CITY OF SOMERVILLE, MASSACHUSETTS
OFFICE OF STRATEGIC PLANNING & COMMUNITY DEVELOPMENT
JOSEPH A. CURTATONE
MAYOR

HISTORIC PRESERVATION COMMISSION

ALTERATION TO A HISTORIC PROPERTY STAFF REPORT

Site: 222 Morrison Avenue c.1873 William Shedd House
Case: HPC 2014.012 Morrison Avenue Local Historic District

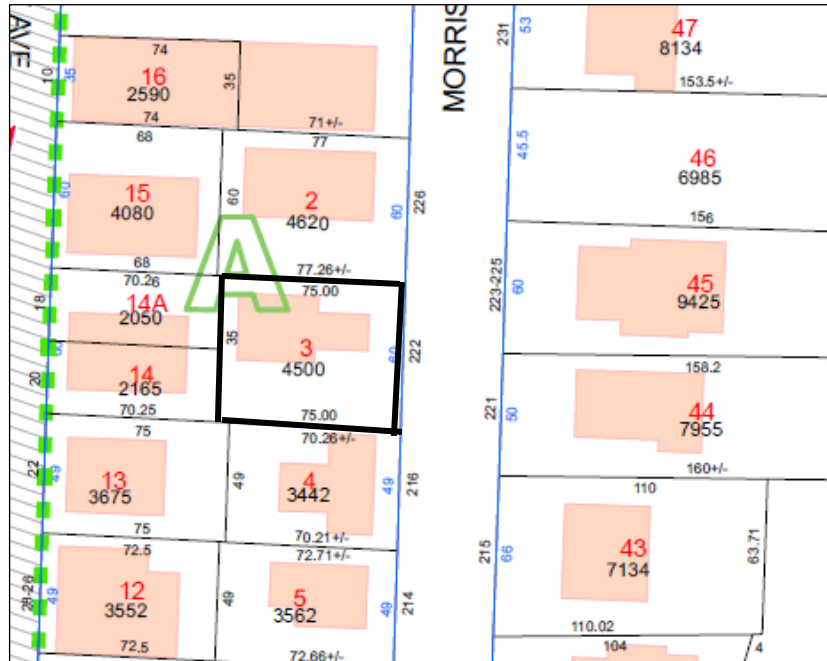
The layout of the front walkway will not be altered. There will be no other grade changes proposed beyond those need to extend and widen the driveway. The materials will be changed from poured concrete to molded concrete blocks and granite posts and wall toppers. See photos.

The Applicant's proposal for a unit block paved parking area will fit in with the neighborhood and not detract significantly from the street. The removal of the concrete wall and the concrete pads, which probably date from the 1950's or 1960's, would have no effect on the visibility or the layout. The installation of the pavers and retaining wall would clearly be modern.

222 Morrison Avenue. 1985

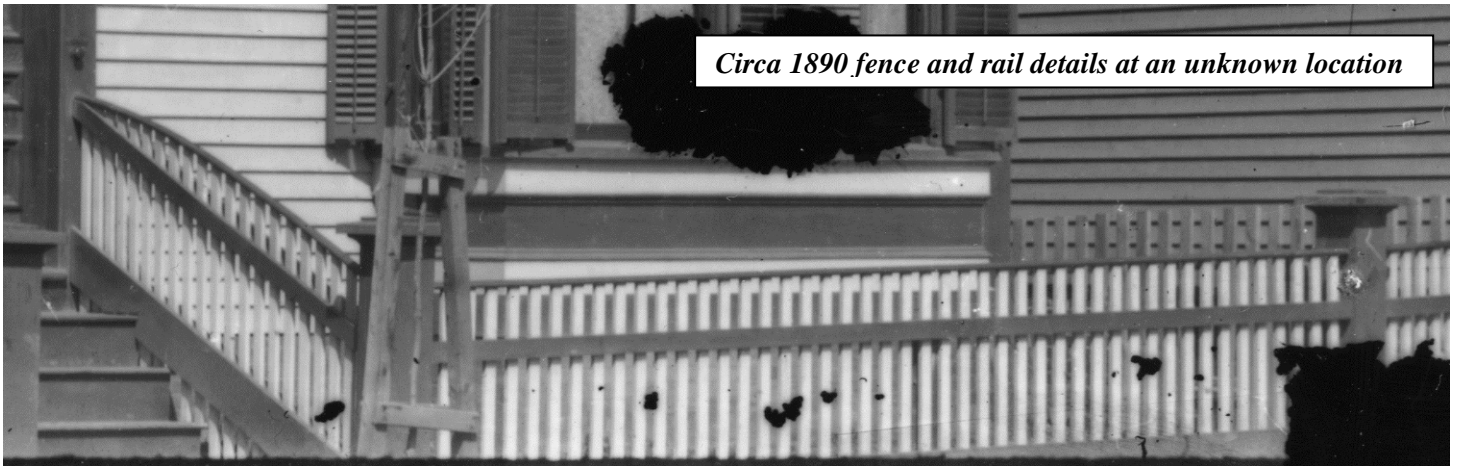
The porch was in poor condition with unsafe decking and broken balusters. As can be seen from the photos, the break in the porch floor and the sinking corner post coincided with the location of the original stairway. The walkways were uneven with broken asphalt. The driveway was dirt. The current fence at the end of the driveway is chain link.

1. If the approval differs from the plans, new plans shall be submitted to Historic Staff prior to commencing the work;
2. The porch may remain as constructed;
3. The path and driveway may remain as constructed;
4. The chain link fence at the end of the driveway shall be replaced with a fence and gate with simple pickets top by a flat rail, a wide bottom rail at the base and a third rail near the top as shown on the photos below.
5. Historic Staff shall issue a sign-off upon completion of the project that this was done in accordance with the Certificate and approved plans.
